The Commission has issued the enclosed Amendment No. 59 to Provisional Operating License No. DPR-19 for Dresden Station Unit 2 and Amendment Nos. 52, 70, and 64 to Facility Operating License Nos. DPR-25, DPR-29, and DPR-30 for Dresden Station Unit 3 and Quad Cities Station Units 1 and 2, respectively. The amendments are in response to your letter of November 1, 1979.

The amendments will allow reactor power ascension to proceed along a modified power/flow line. This will facilitate adherence to procedures designed to reduce fuel pellet-clad interaction.

By letter dated November 1, 1979 (Reference 1), Commonwealth Edison Company (CECo, the licensee) proposed amendments to Appendix A, Technical Specifications for Operating License Nos. DPR-19, DPR-25, DPR-29 and DPR-30 for Dresden Units 2 and 3 and Quad Cities Units 1 and 2, respectively. The change involves a modified power/flow line, which provides more operating flexibility during power ascension while adhering to procedures aimed at reducing fuel pellet-clad interaction.

The amendments authorize changes to the Technical Specifications which will allow reactor power ascension to proceed along a modified power/flow line.

FIGURE 2.1-3 (SCHEMATIC)

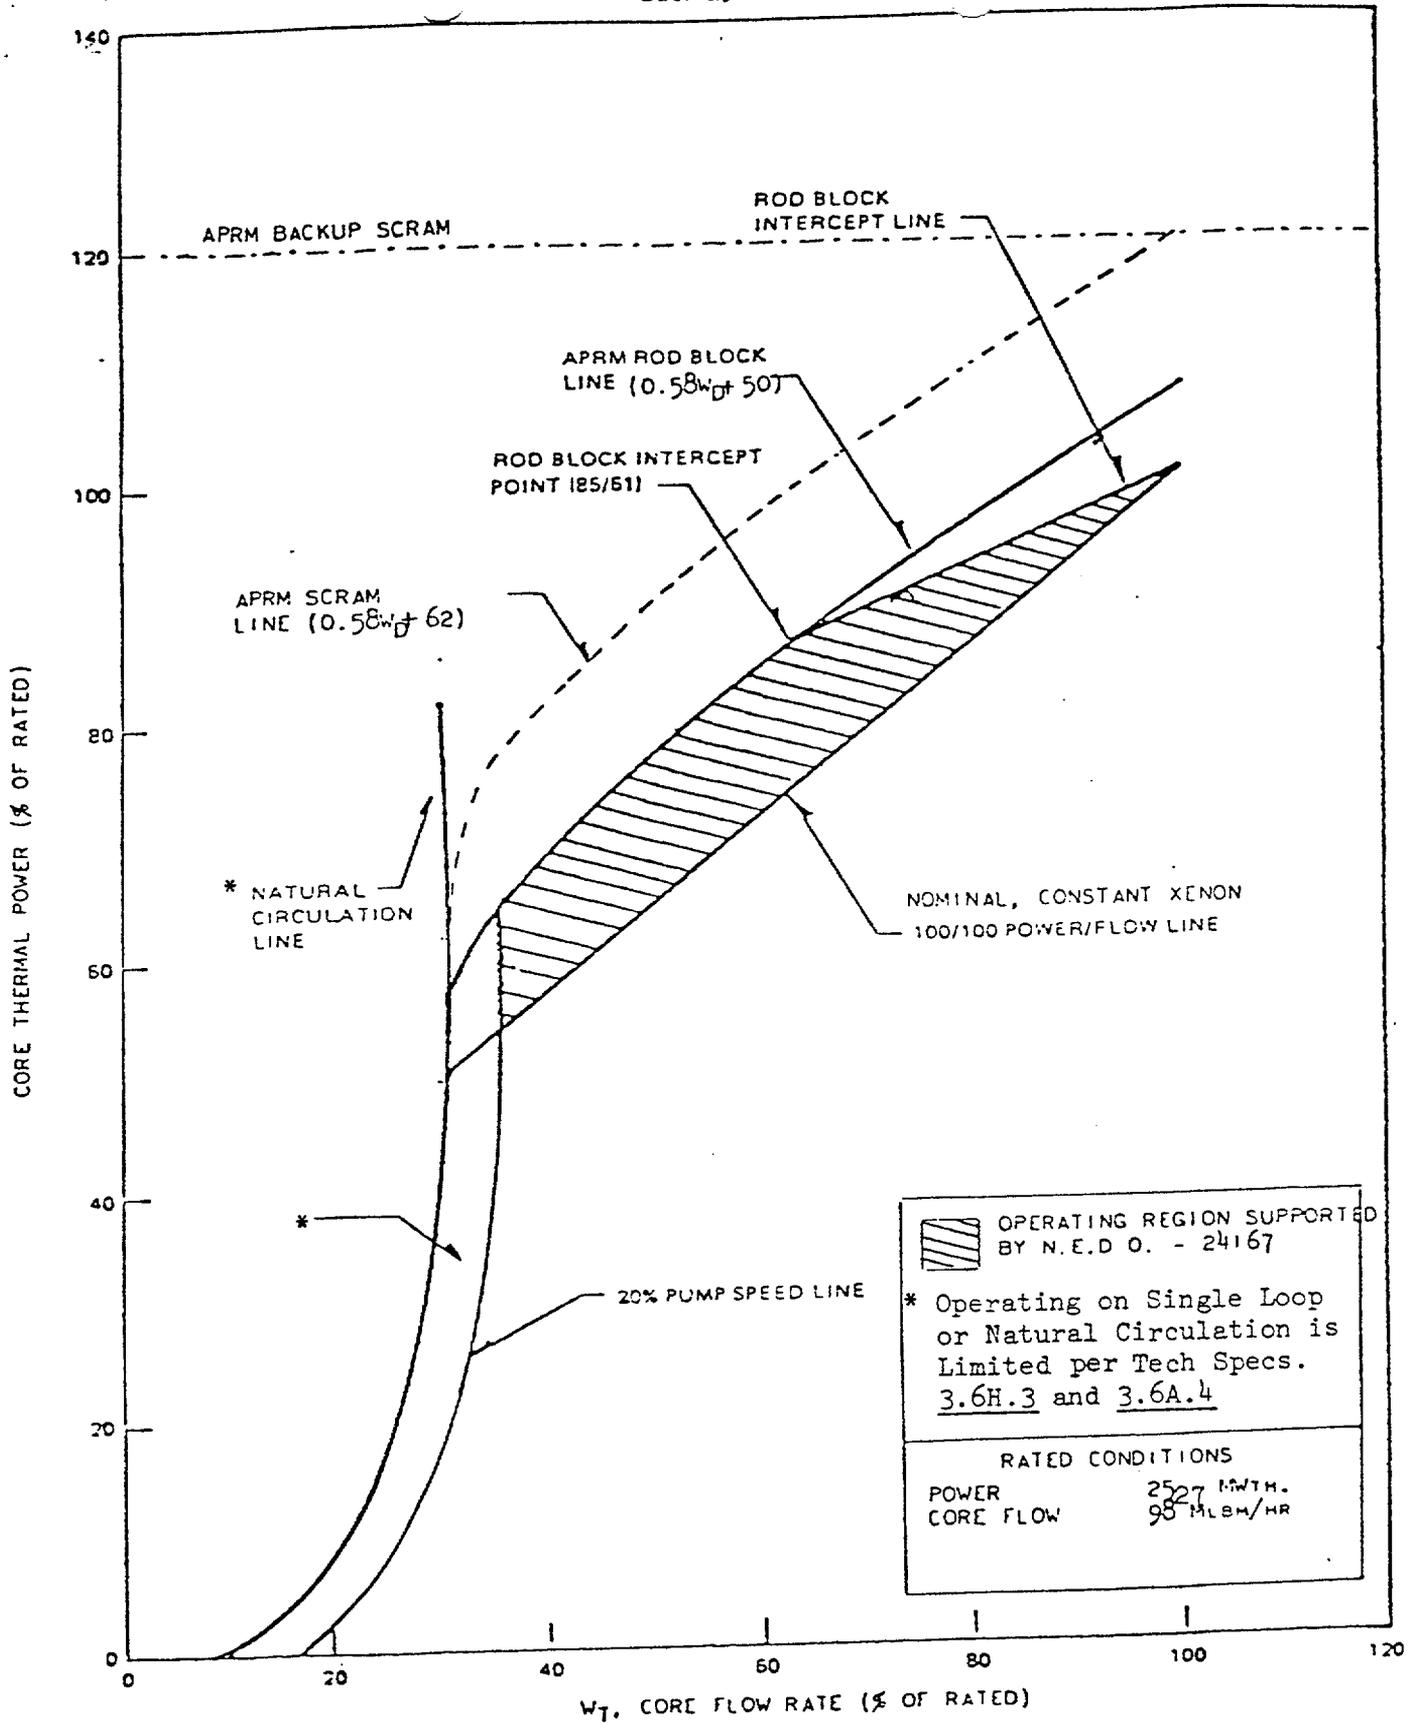
APRM FLOW BIAS SCRAM RELATIONSHIP TO NORMAL OPERATING CONDITIONS

FIGURE 2.1-1

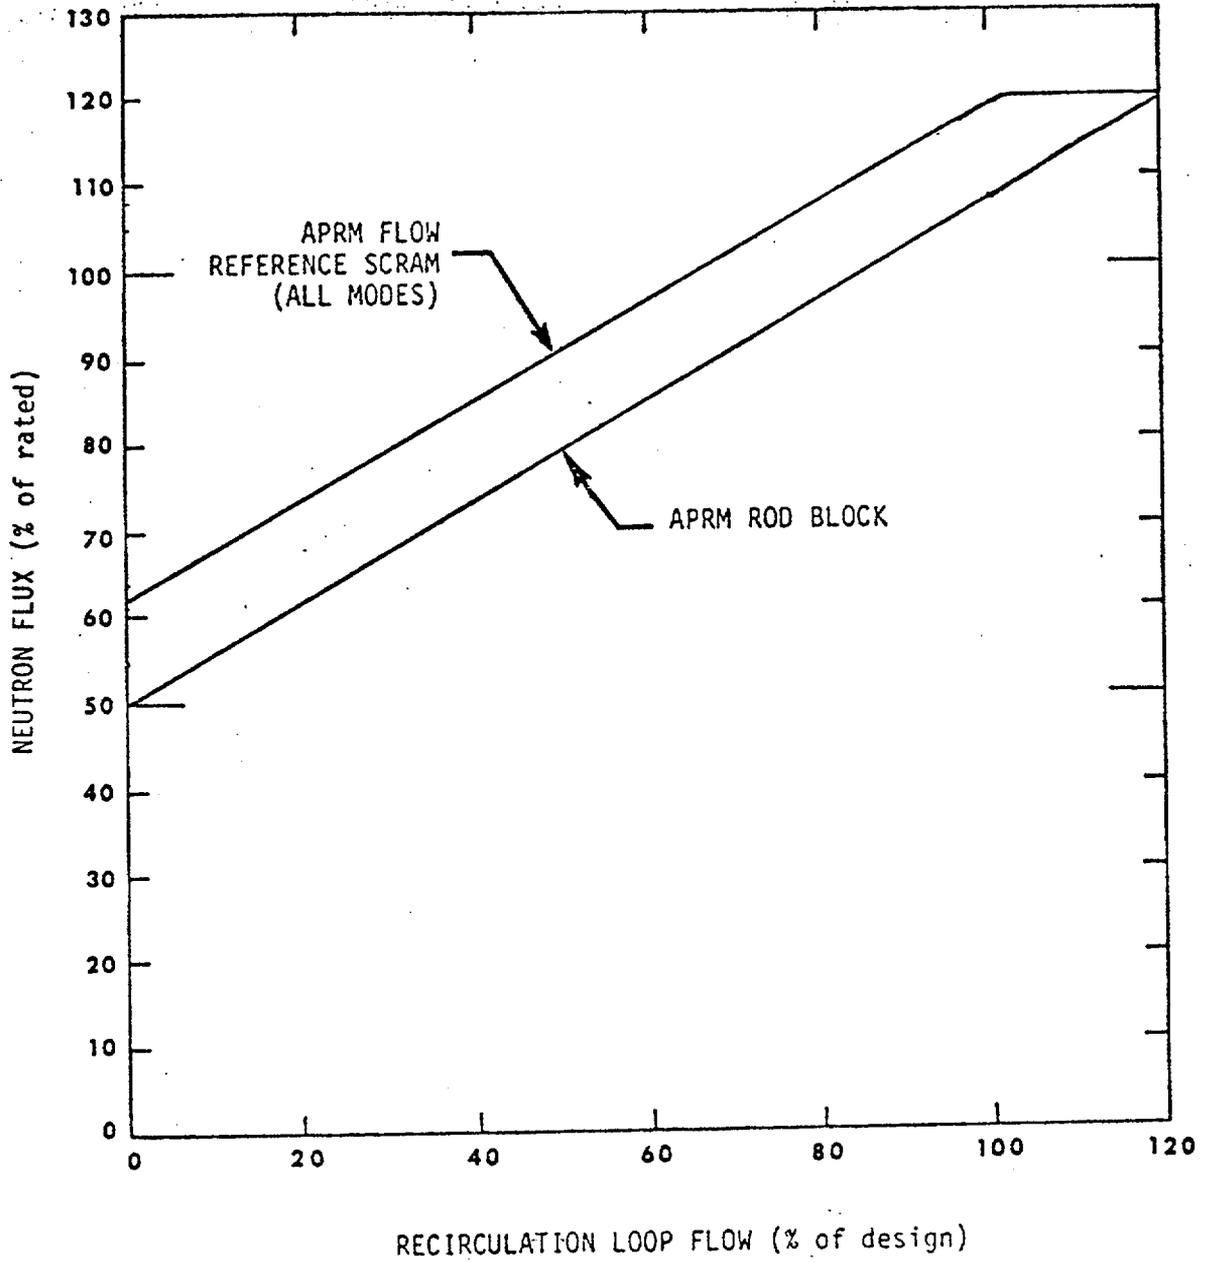
The APRM rod block setting shall be as shown in Figure 2.1-1 and shall be:

$$S \leq (.58W_D + 50)$$

FIGURE 2.1-3
(SCHEMATIC)

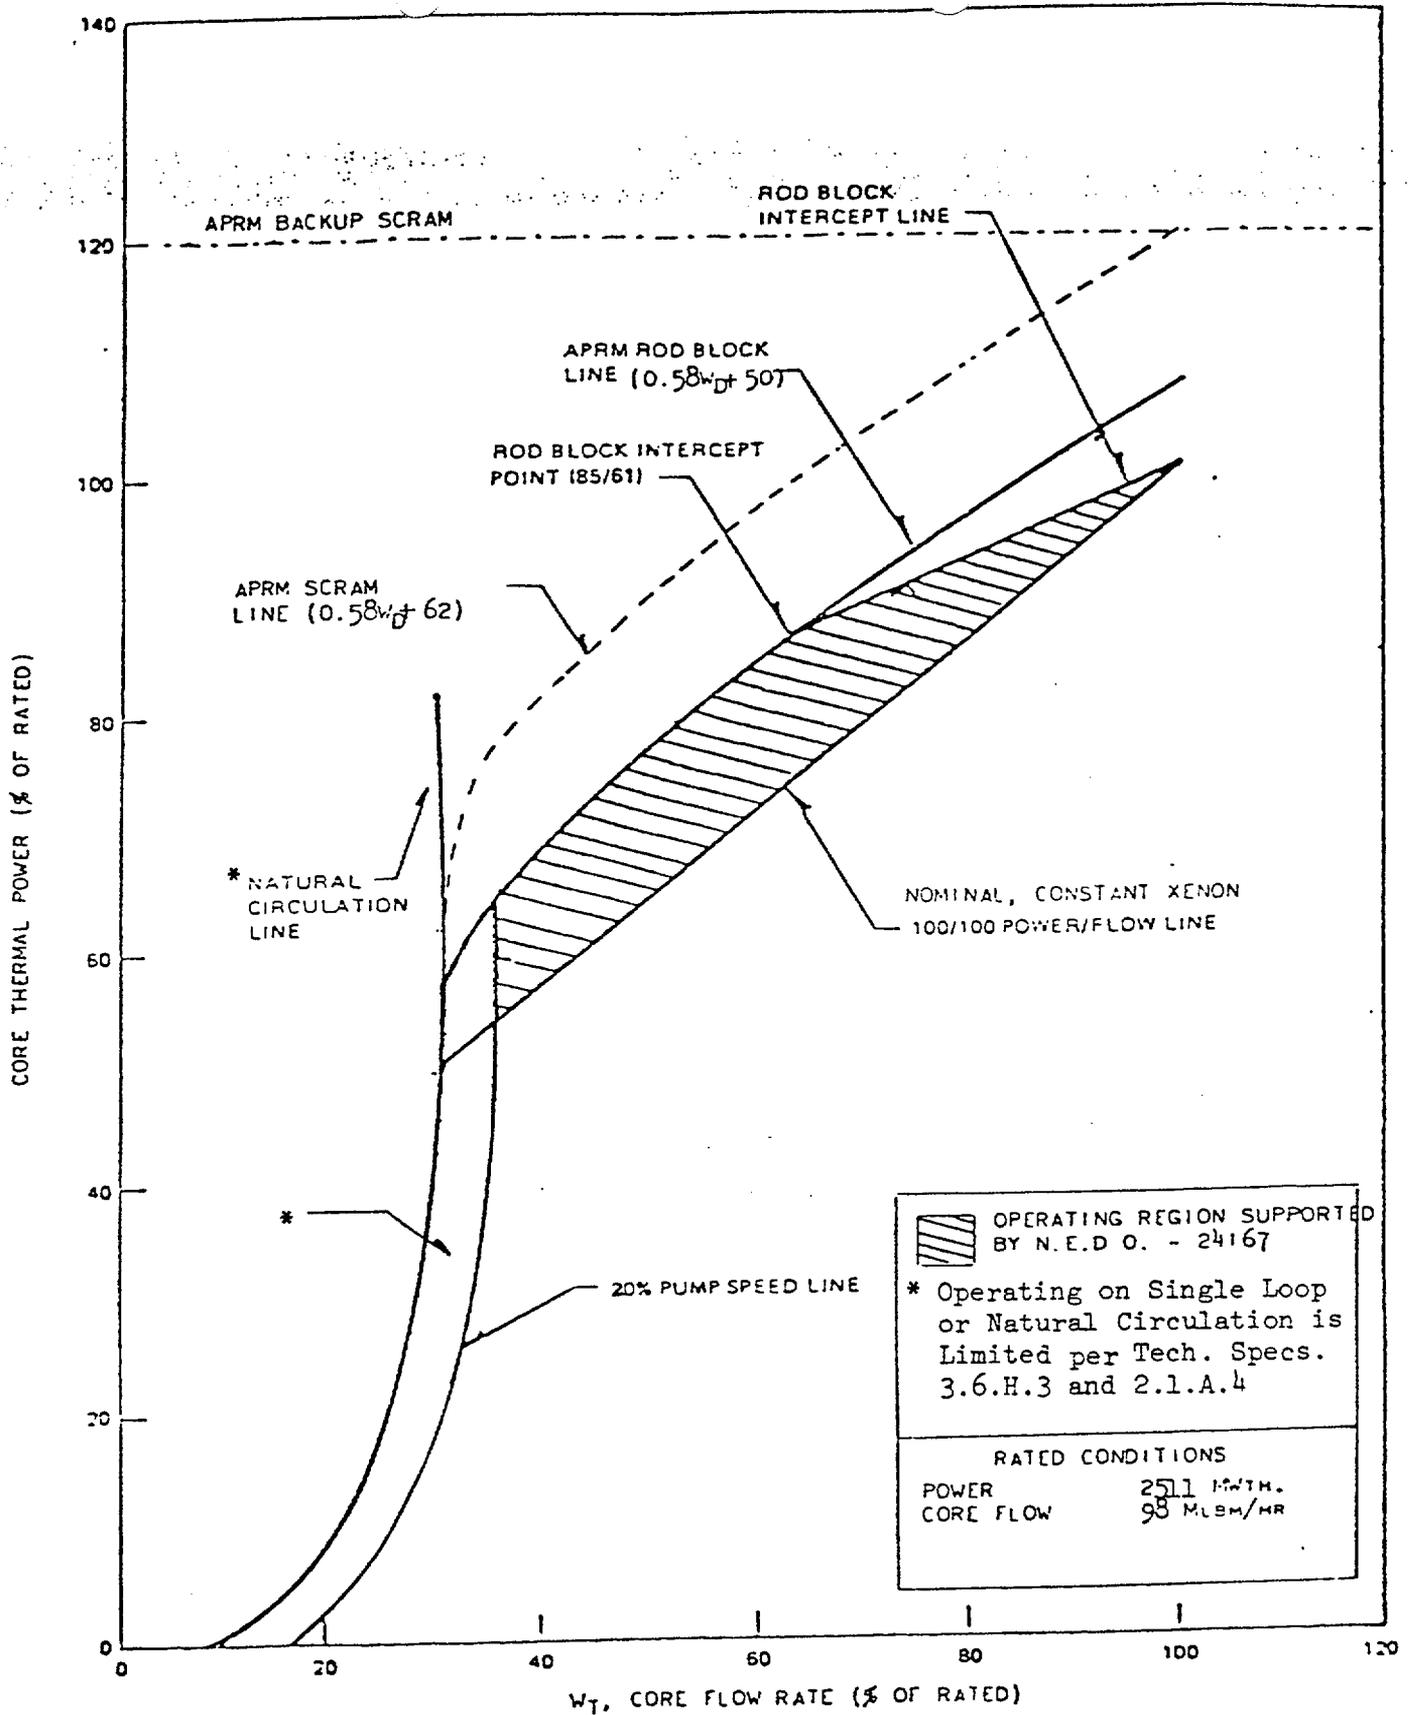
APRM FLOW BIAS SCRAM RELATIONSHIP
TO NORMAL OPERATING CONDITIONS

FIGURE 2.1-1

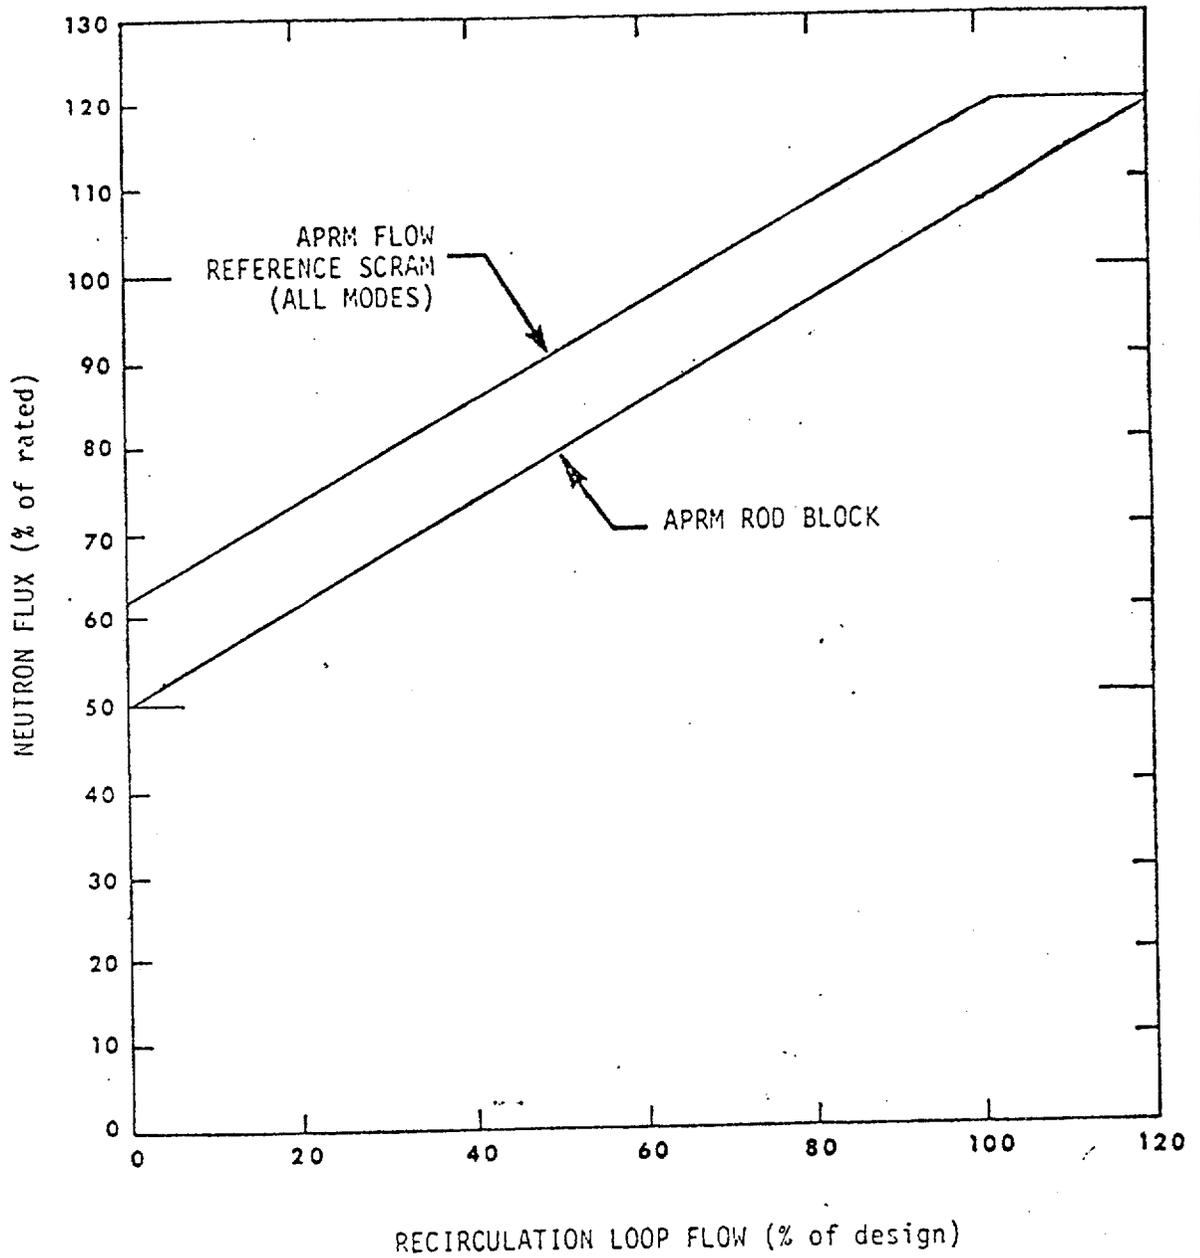
The APRM rod block setting shall be as shown in Figure 2.1-1 and shall be:

$$S \leq (0.58W_D + 50)$$

FIGURE 2.1-3
(SCHEMATIC)

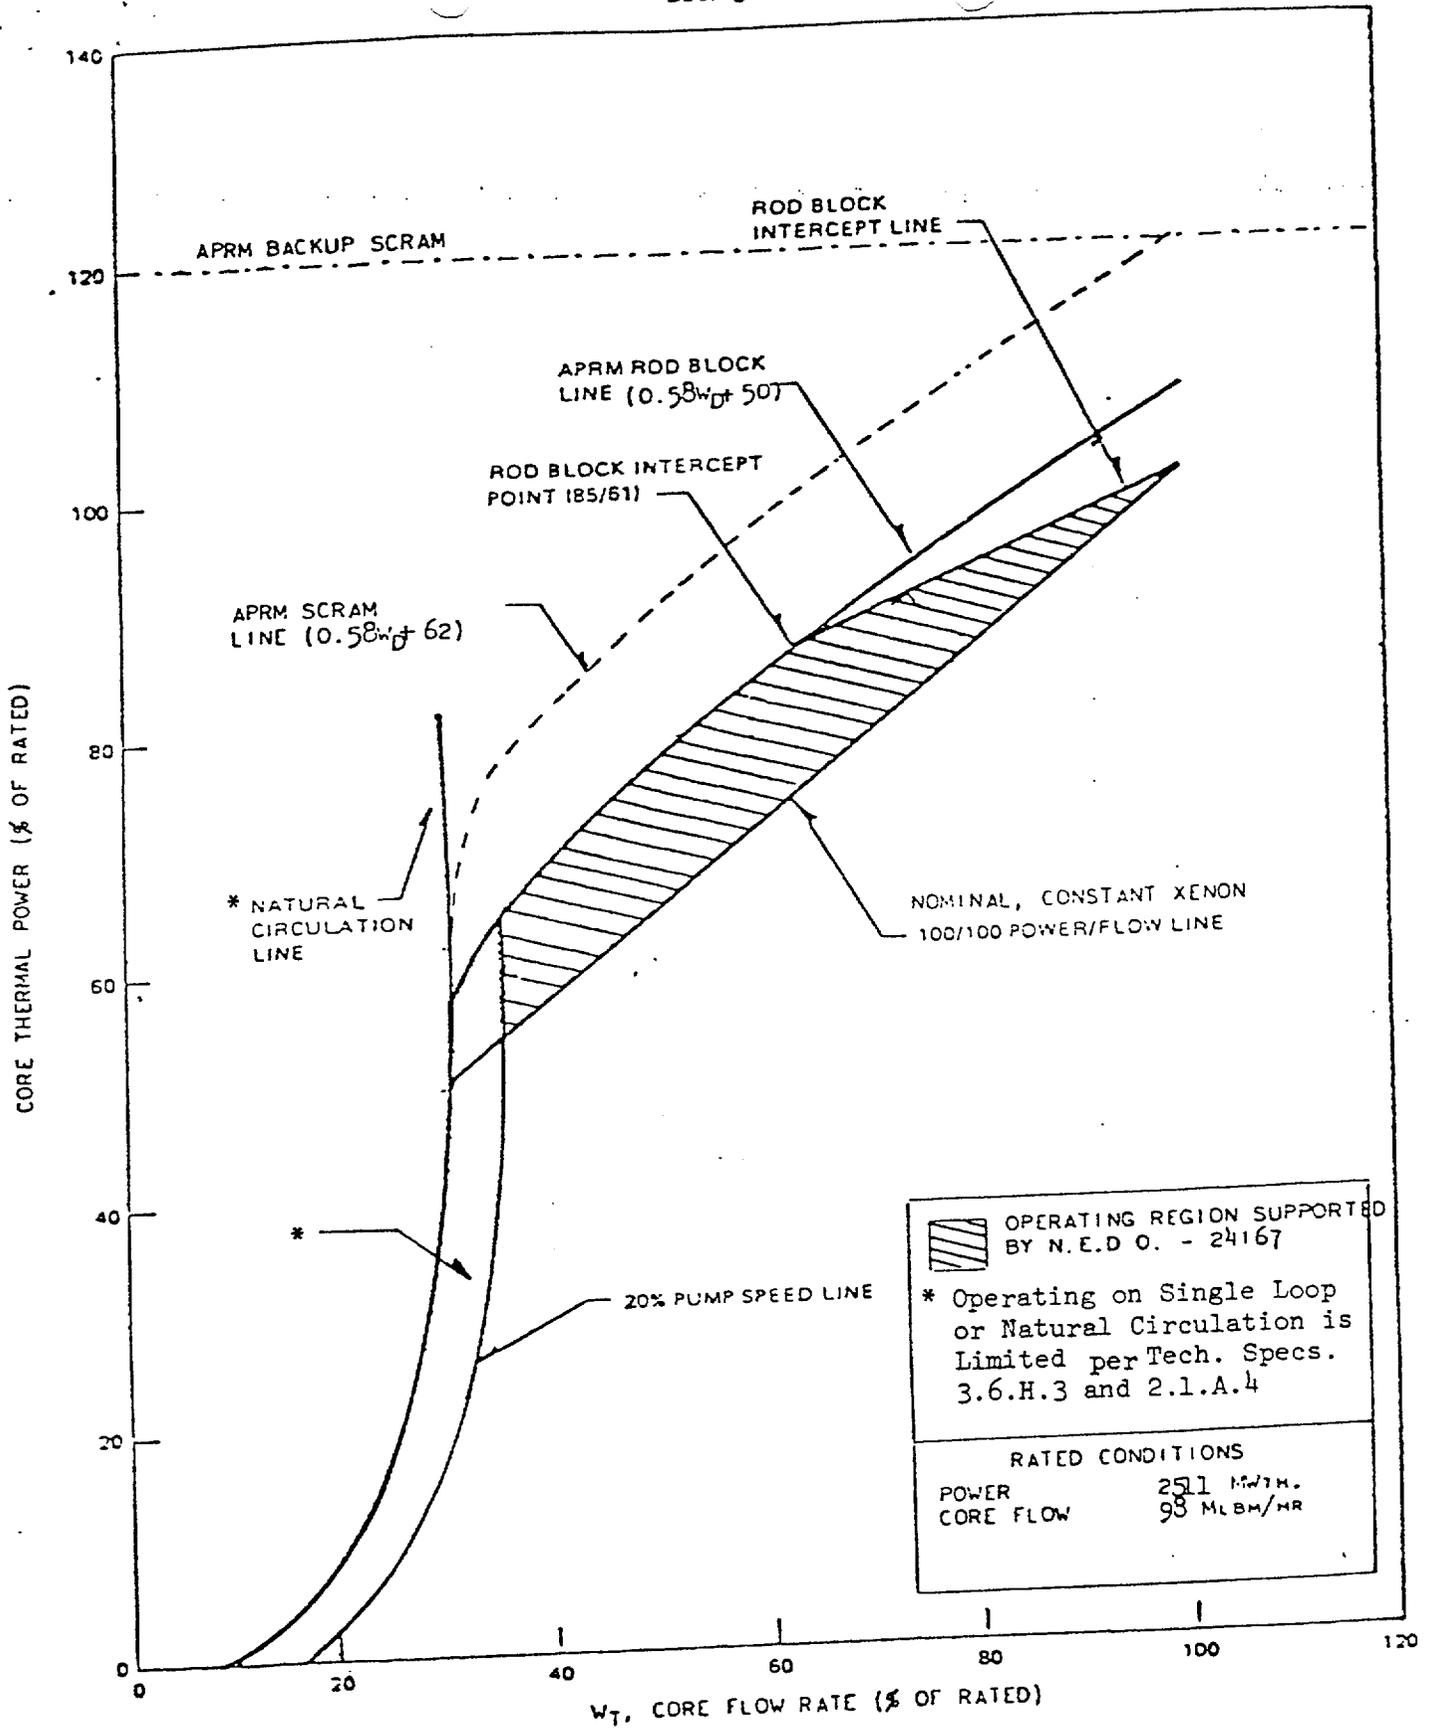
APRM FLOW BIAS SCRAM RELATIONSHIP
TO NORMAL OPERATING CONDITIONS
